Amendments to LBCs
PL/2023/10864 (2nd Floor Bathroom)
&
PL/2023/01416 (Main Application)

Picture 1a – 14 New Canal Shop Lobby to reintegrate in the staircase

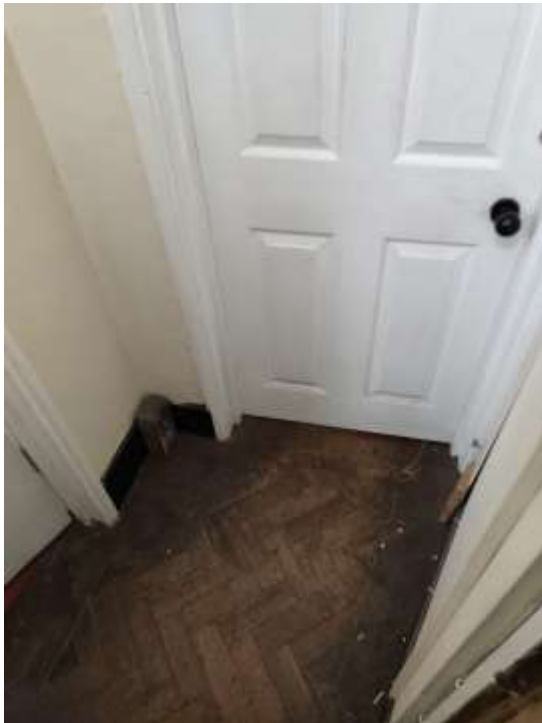
14 New Canal (half-landing): The shop's emergency exit is no longer required. The small lobby ($\approx 0.8 \text{ m}^2$) will be reintegrated into the communal staircase as it was before the post-1985 conversion into three shop units, reinstating the previous configuration; modern FD30 doors will be removed. (Pictures 1a,1b,1c)
